PLANNING REF: 243124

PLANNING APPLICATION NUMBER 243124

Site Address: Land At Bridge Farm Bridge Farm Lane Twyford

In respect of Flood Risk and Drainage, I object to the discharge of Planning Conditions 25, 26 and 29. The details provided in Stuart Michael Associates Technical Note Ref 7236.TN02 Rev04 dated 9th December 2024 (SMA) and its Appendices are incomplete and/or inadequate.

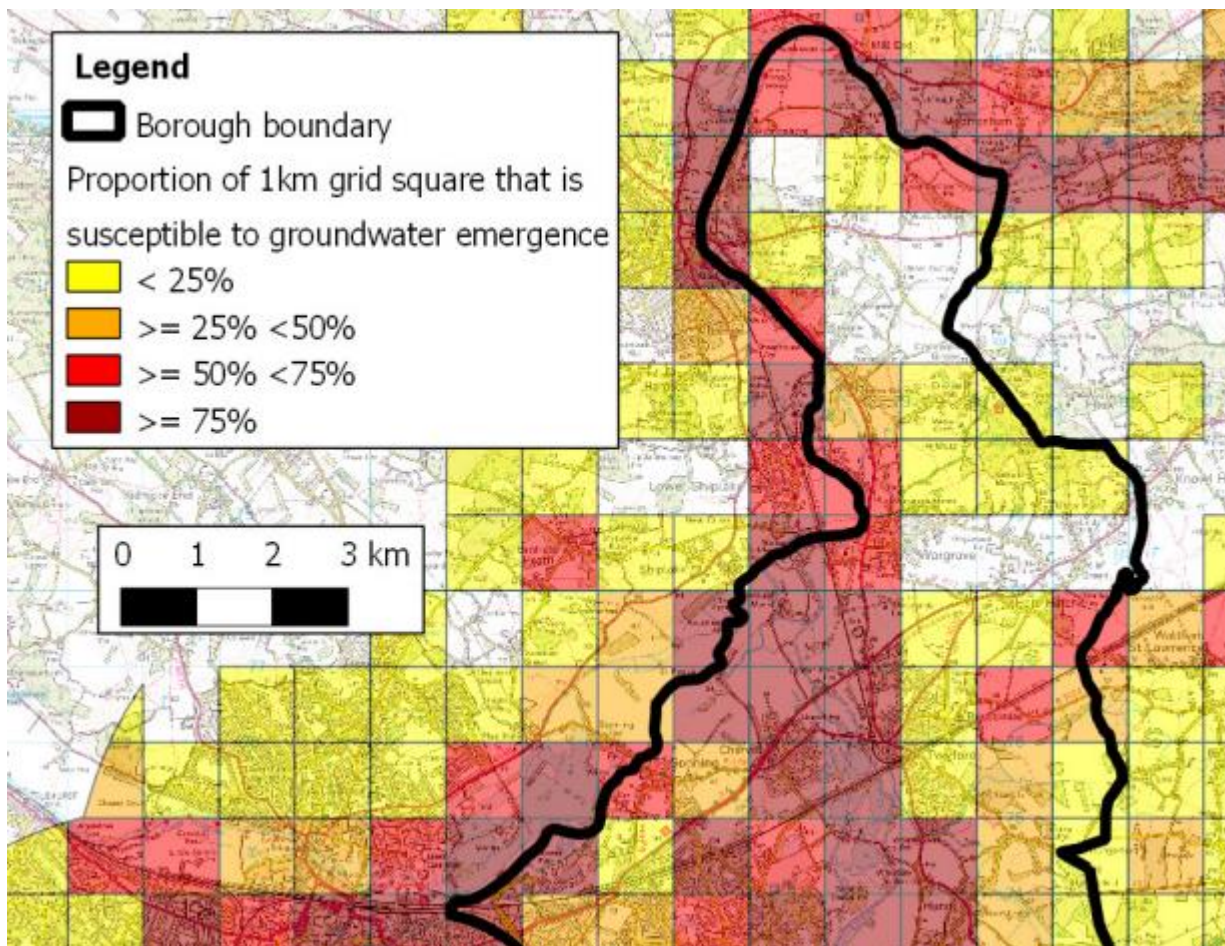
This may well be the case in respect of Fluvial Flooding however this does not consider high groundwater levels and / or groundwater flooding. Please refer to my comments below.

Data from British Geological Survey Memoir (Wartime pamphlet. Geological Survey of Great Britain, 15).

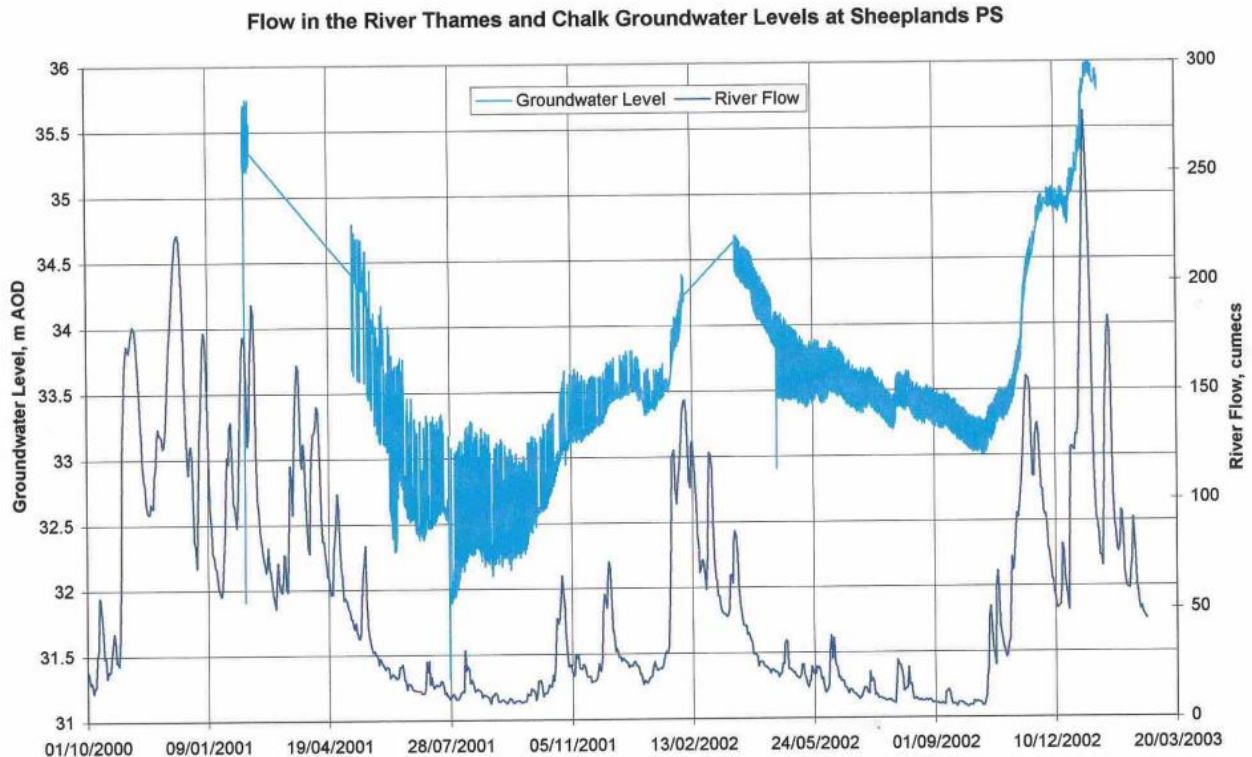
1929 Winter Rest Water Level is 35.75m AOD, only just below the minimum finished floor level specified in Condition 25.

The site is up gradient from Sheeplands so groundwater levels will naturally be higher at the development site than at Sheeplands.
